Burlington Design Advisory Board

ZP-24-276; 206-208 Dale Road (RL, Ward 4) Wild Dale, LLC / Matt Brouillard
Proposed construction of a new duplex on existing vacant lot created under ZP-24-159. (Project Manager, Mary O’Neil)

MEMORANDUM

To: The Design Advisory Board
From: Mary O'Neil, AICP, Principal Planner
RE: ZP-24-276
Location: 206-208 Dale Road
Date: July 23, 2024

SHEET NUMBER
A2.1

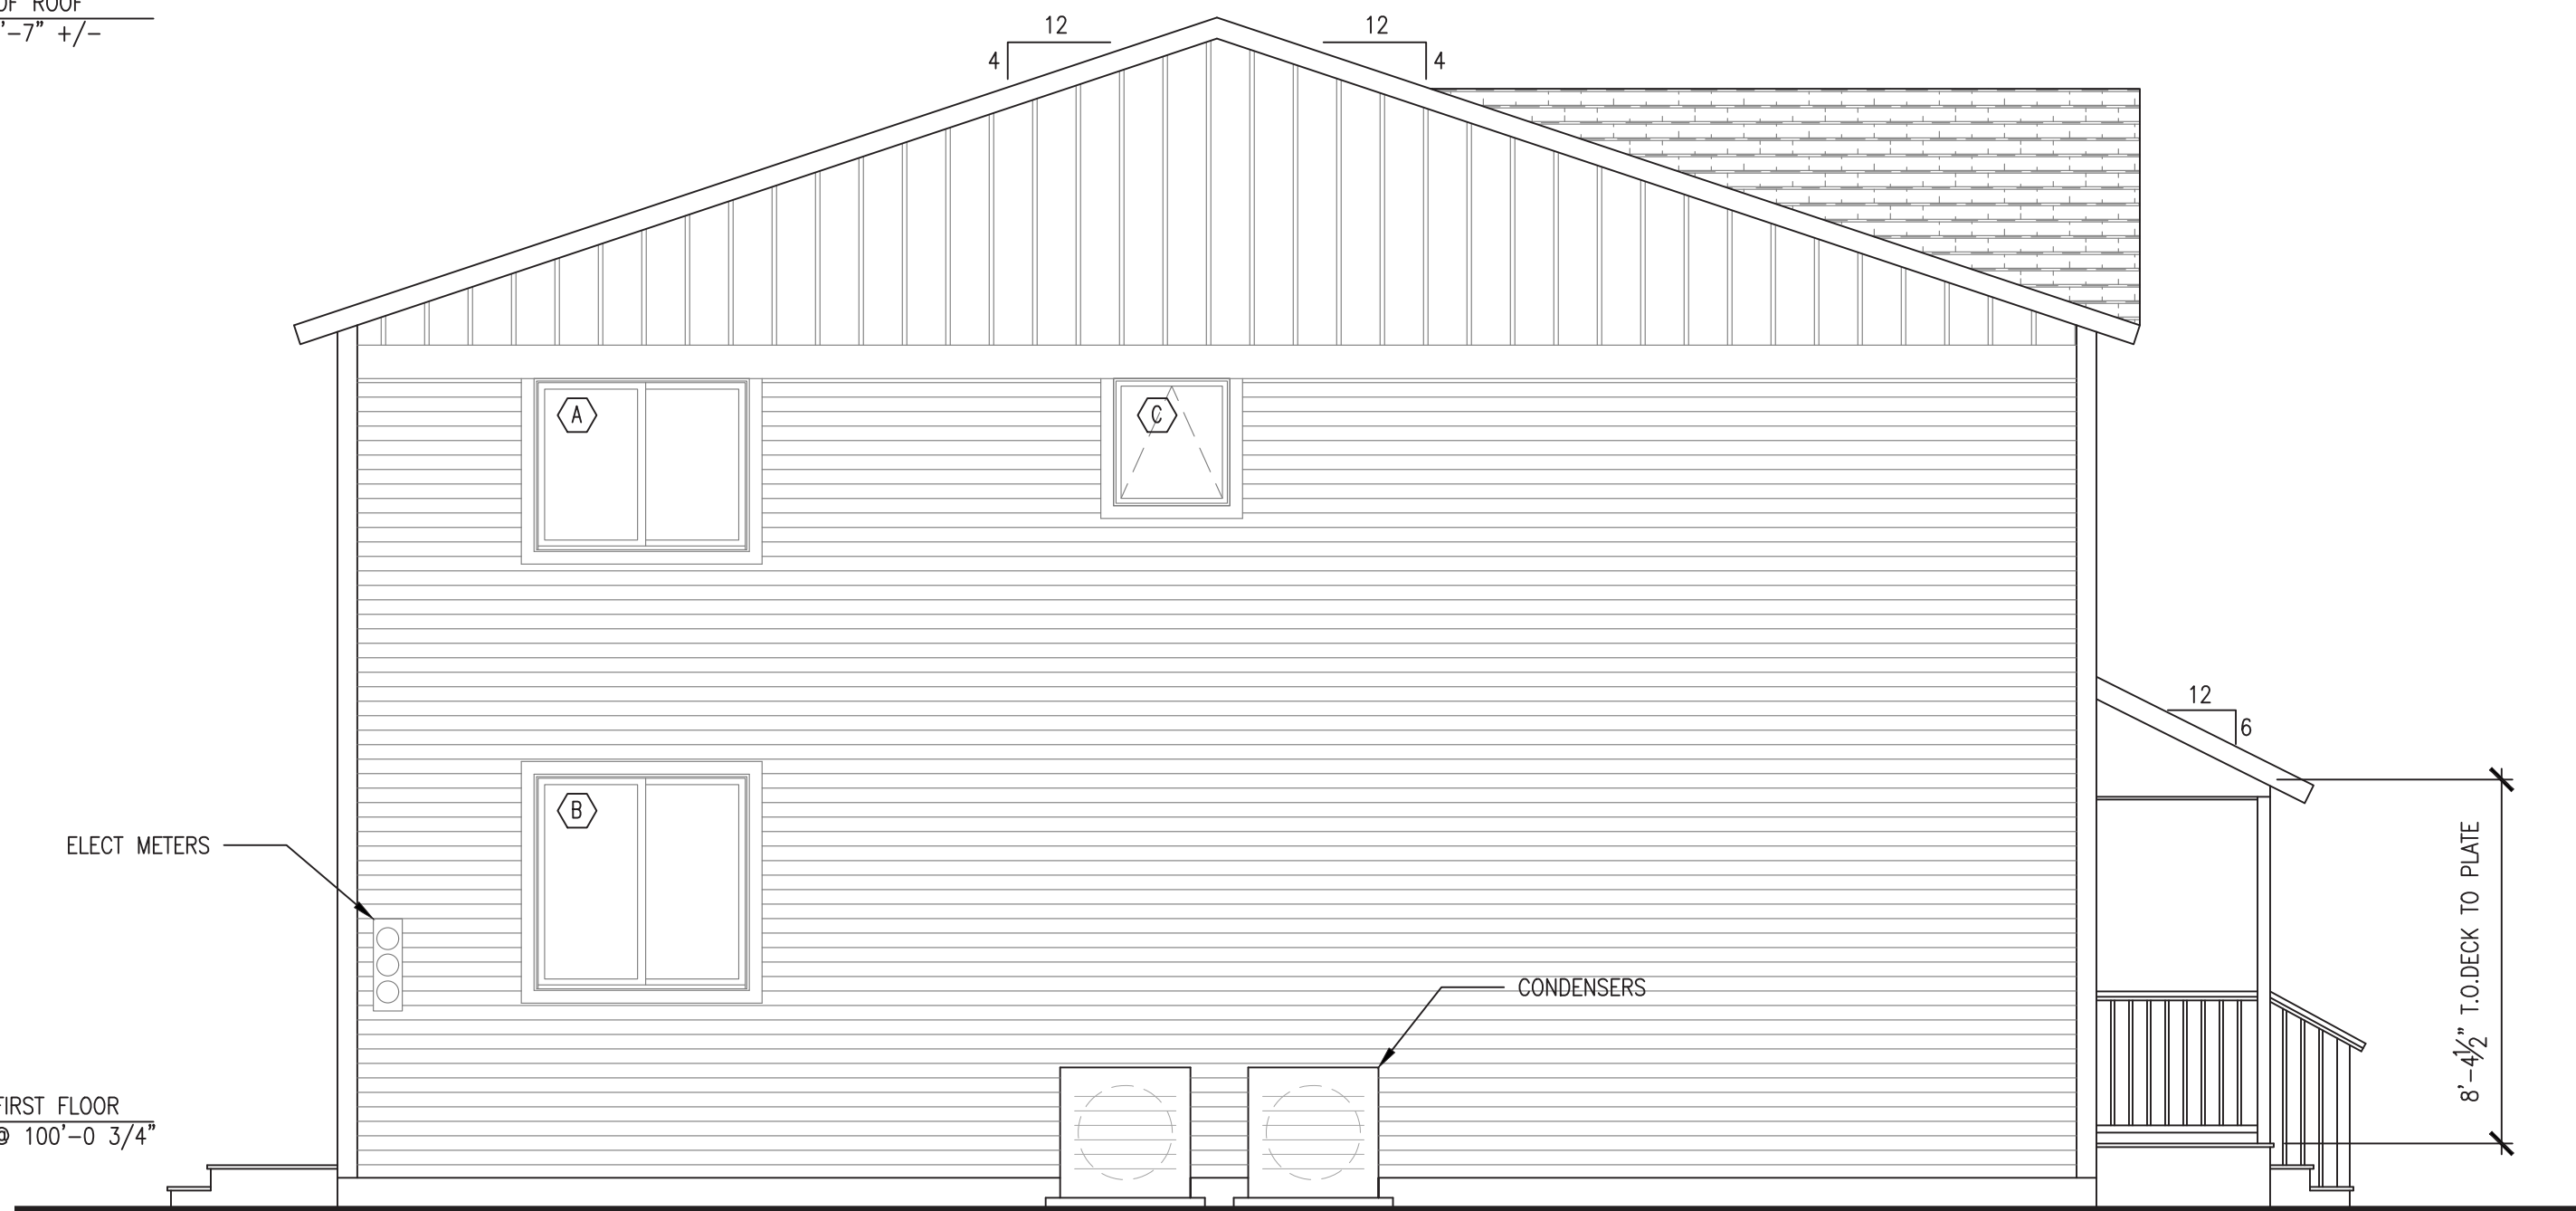
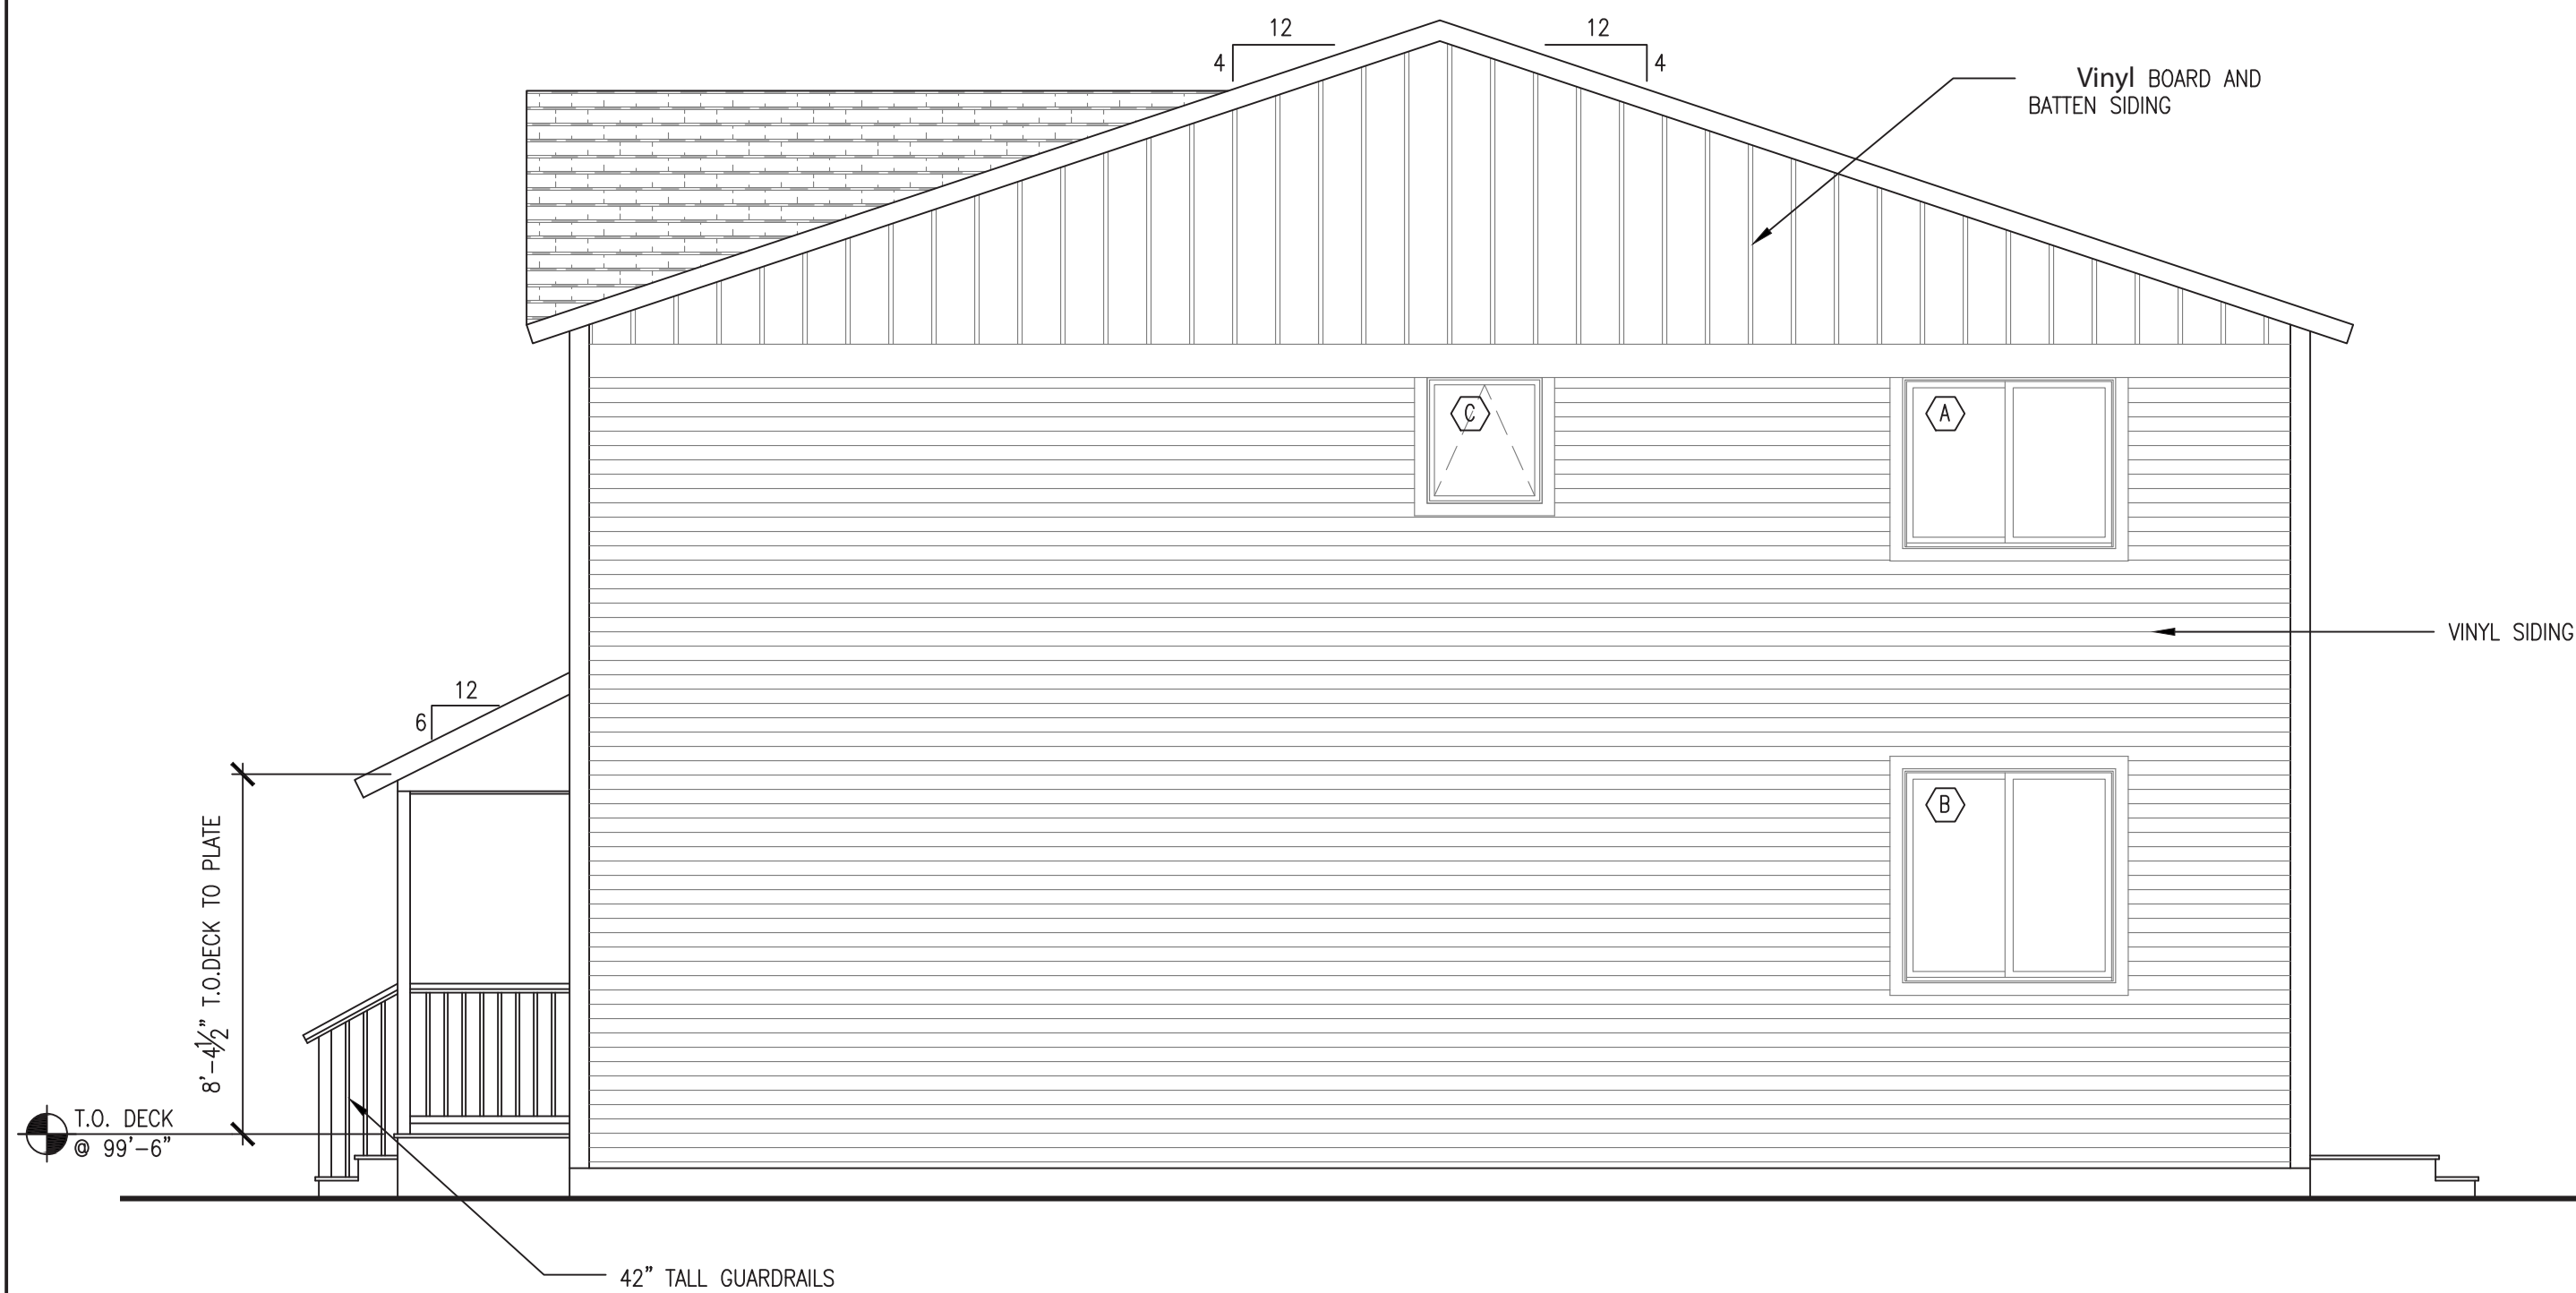
Condensing units are illustrated at the northwest (side) elevation. Mailboxes are adjacent to front entrances. Trash and recycling will be located within the garages. Utility meters are located on a side (northwest) elevation. Reference is made to Plan A2.1.

There remain large expanses of blank walls on the north and south elevations that could improve the livability of the units and provide additional interior daylighting if more windows were included. To successfully achieve these goals, a revised floor plan is recommended, placing interior stairs along interior party walls rather than along exterior walls.

Windows have been symmetrically placed across all elevations. The deficiency in the plan is the dearth of windows on north and south elevations, resulting from the proposal to arrange interior stairs along exterior walls. (This was a similar weakness

Plan A2.1 defines the intention of asphalt shingle roofing, composite board and batten in the gable ends and vinyl siding for the bulk of the structure. All are considered acceptable for new construction.

6. A revised floor plan is strongly recommended; placing interior stairs along party walls to accommodate more windows along northwest and southeast elevations. Revisions will allow for expanded opportunities for daylight into interior rooms, increased air circulation, and an improved floor plan allowing greater resident enjoyment.
